MIL-C-29600
AMENDMENT 3
6 August 1999
SUPERSEDING
AMENDMENT 2
4 May 1990

CONNECTORS, ELECTRICAL, CIRCULAR, MINIATURE, COMPOSITE, HIGH DENSITY, QUICK COUPLING, ENVIRONMENT RESISTANT, REMOVABLE CRIMP CONTACTS ASSOCIATED HARDWARE, GENERAL SPECIFICATION FOR

This amendment forms a part of MIL-C-29600, dated 20 December 1989, and is approved for use by all Departments and Agencies of the Department of Defense.

FIGURE 5. Connector accessory interface dimensions (series A) - continued.

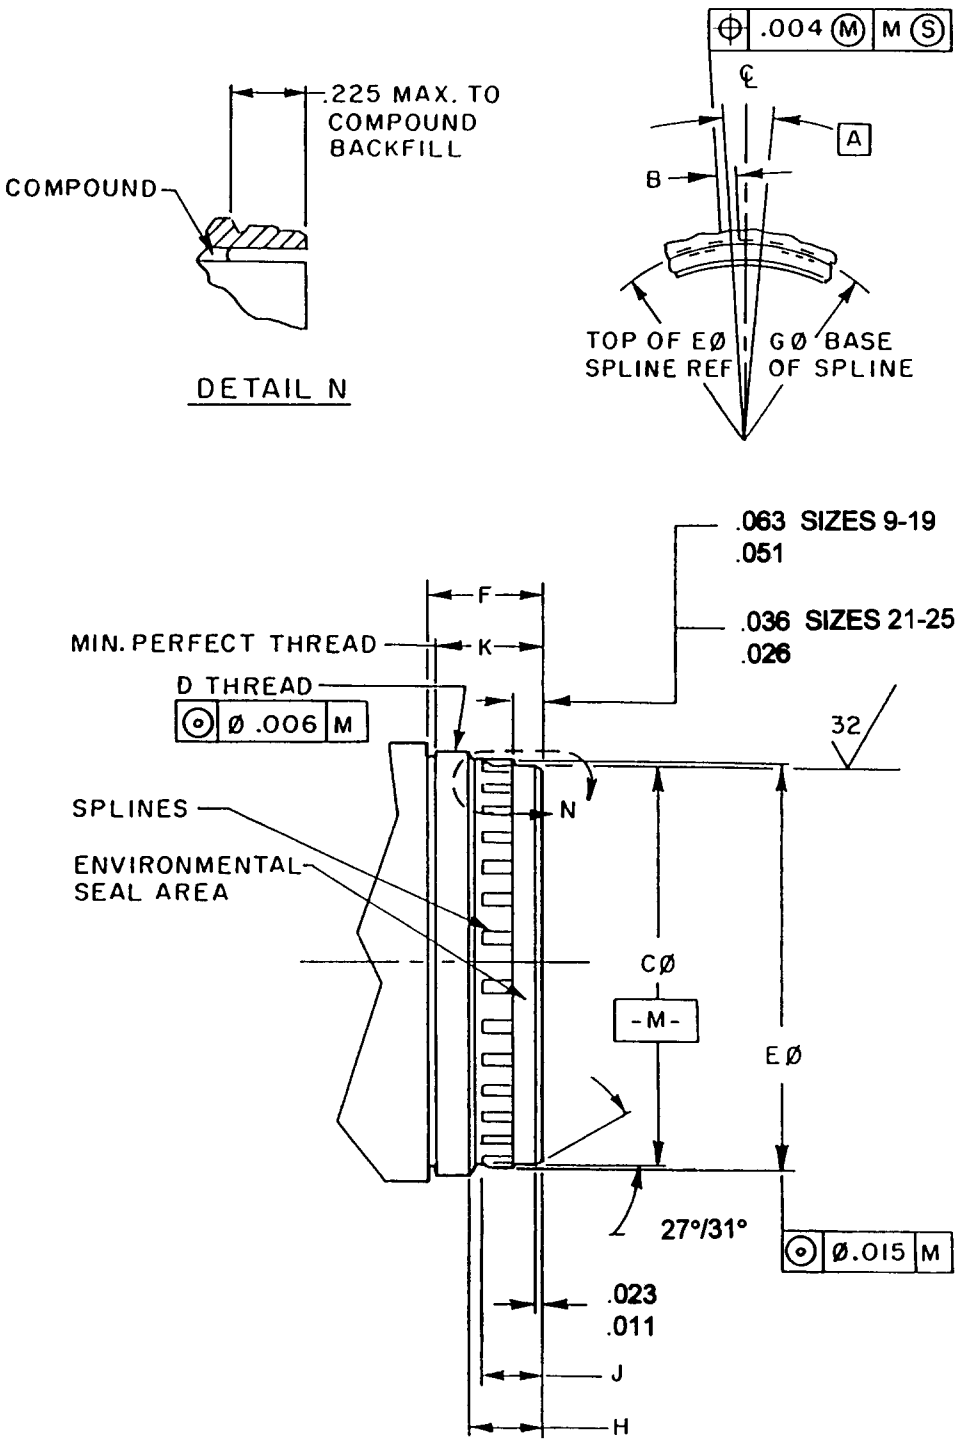
* Figure 5: Delete Figure 5 and substitute attached Figure 5.

* Figure 5, dimension table: Delete and substitute:

Shell size	A° Bsc	B	C	D Thread	E∅	F Min	G∅ Max	H	J Min	K Min
9	20	0.051 0.046	0.430 0.424	.500-28UNEF-2A	0.462 0.454		0.439			
11	15	0.049 0.044	0.555 0.549	.625-28UN-2A	0.587 0.579		0.564			
13	12	0.048 0.043	0.676 0.670	.750-28UN-2A	0.708 0.700		0.685			
15	12	0.054 0.049	0.805 0.799	.875-28UN-2A	0.837 0.829	0.257	0.814	0.157 0.127	0.107	0.237
17	10	0.053 0.048	0.930 0.924	1.000-28UN-2A	0.962 0.954		0.939			
19	9	0.053 0.048	1.055 1.049	1.125-28UN-2A	1.087 1.079		1.064			
21	9	0.059 0.054	1.180 1.174	1.250-28UN-2A	1.212 1.204		1.189			
23	9	0.062 0.057	1.305 1.299	1.375-28UN-2A	1.337 1.329	0.276	1.314	0.158 0.128	0.108	0.263
25	9	0.069 0.064	1.430 1.424	1.500-28UN-2A	1.462 1.454		1.439

FIGURE 10. Connector accessory interface dimensions (series B).

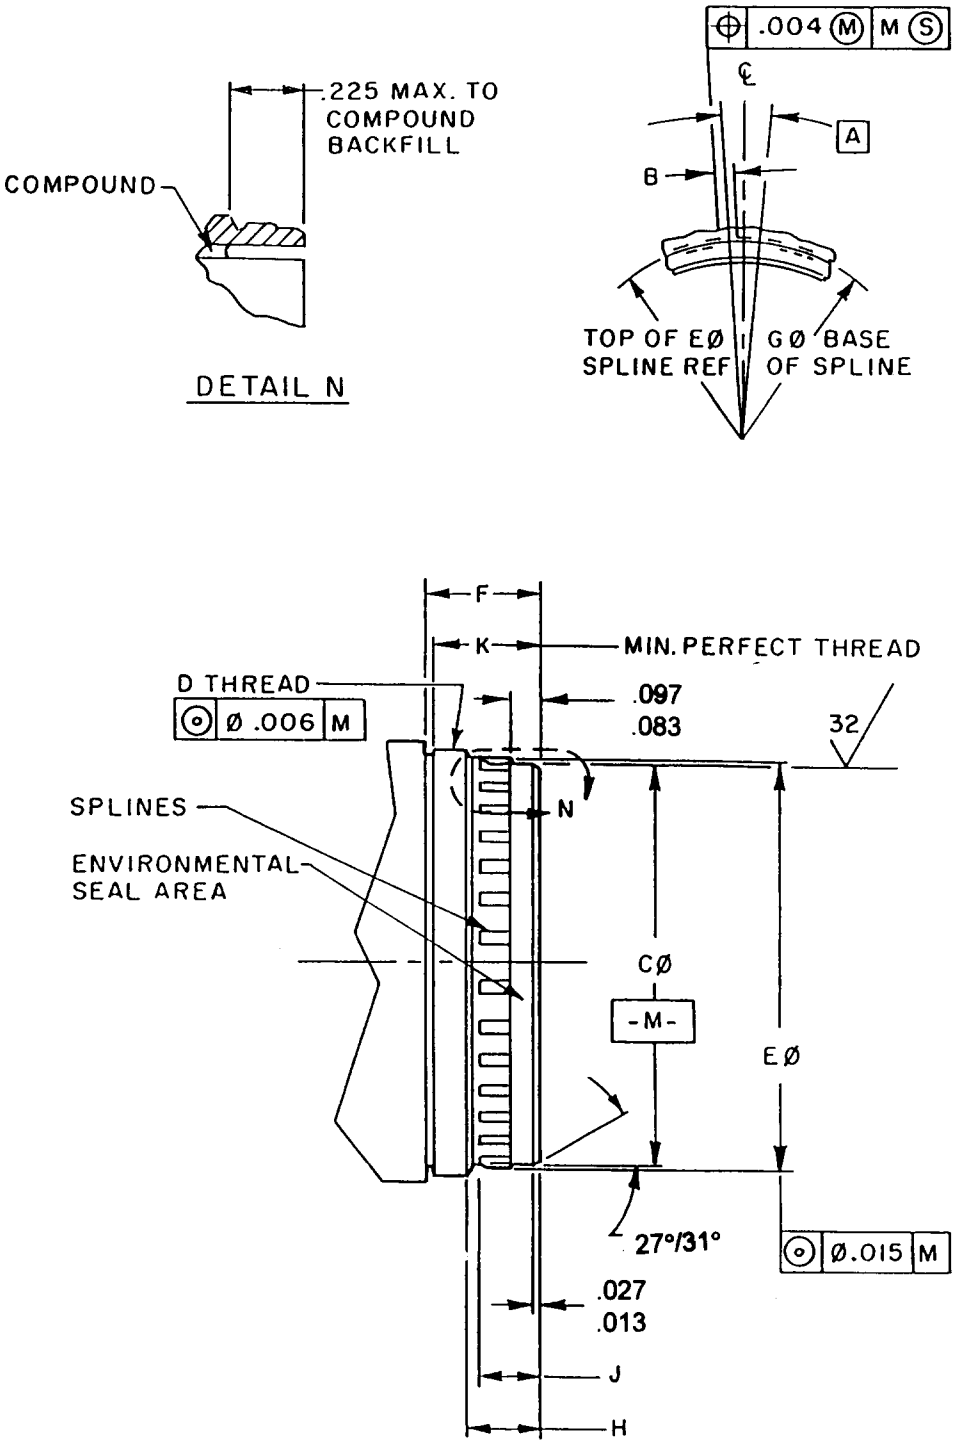
Figure 10: Delete and substitute attached Figure 10.

* FIGURE 10, dimension table: Delete and substitute:

Shell size	A° Bsc	B	C	D Thread	E∅	F Min	G∅ Max	H	J Min	K Min
8	20	0.051 0.046	0.430 0.424	.500-28UNEF-2A	0.462 0.454	0.300	0.439	0.190 0.160	0.140	0.270
10	15	0.049 0.044	0.555 0.549	.625-28UN-2A	0.587 0.579		0.564			
14	12	0.054 0.049	0.805 0.799	.875-28UN-2A	0.837 0.829		0.814			
16	10	0.053 0.048	0.930 0.924	1.000-28UN-2A	0.962 0.954		0.939			
18	9	0.053 0.048	1.055 1.049	1.125-28UN-2A	1.087 1.079		1.064			
20	9	0.059 0.054	1.180 1.174	1.250-28UN-2A	1.212 1.204	0.338	1.189	0.220 0.190	0.170	0.325
22	9	0.062 0.057	1.305 1.299	1.375-28UN-2A	1.337 1.329		1.314			
24	9	0.069 0.064	1.430 1.424	1.500-28UN-2A	1.462 1.454		1.439

FIGURE 19. External bending moment test set-up.

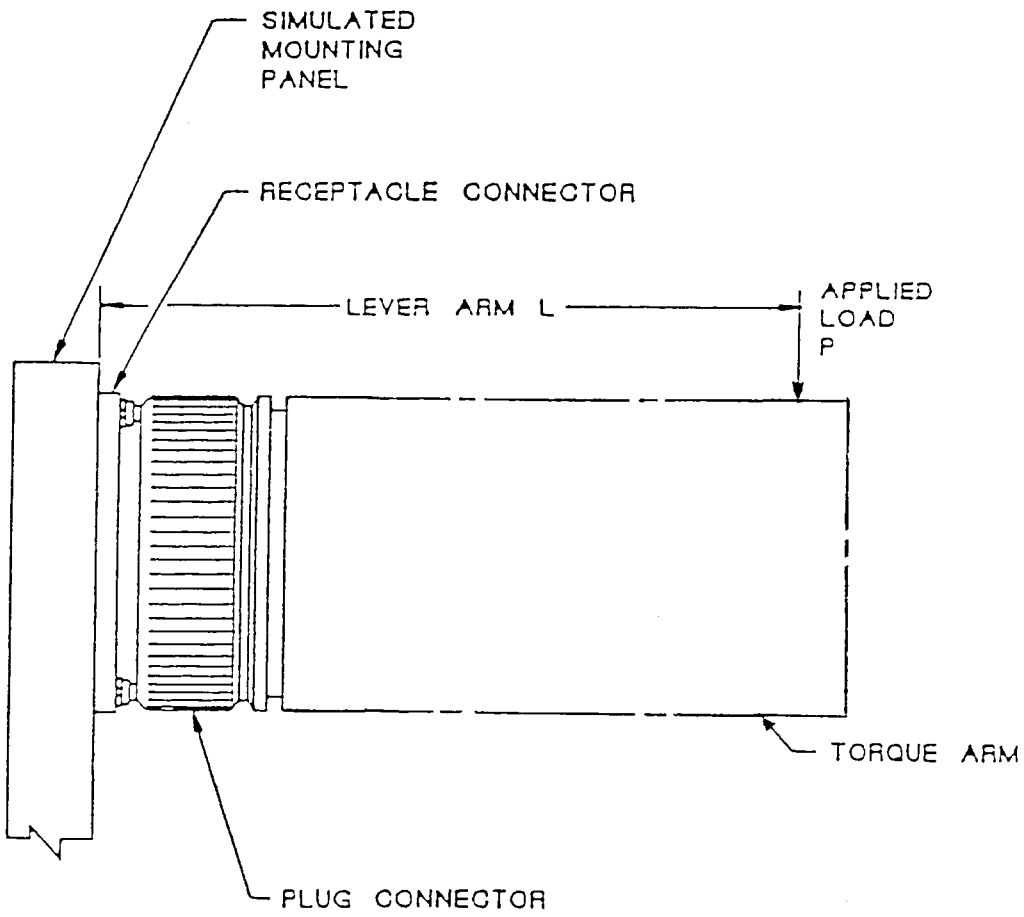
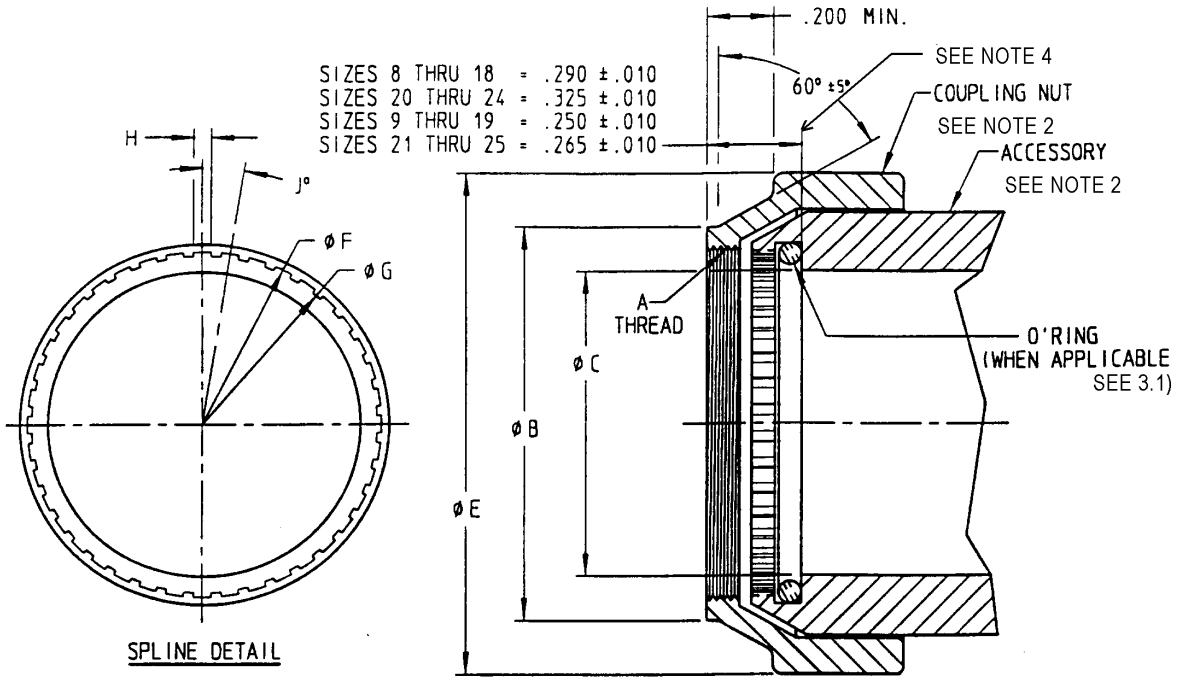
* FIGURE 19: Delete and substitute attached Figure 19.
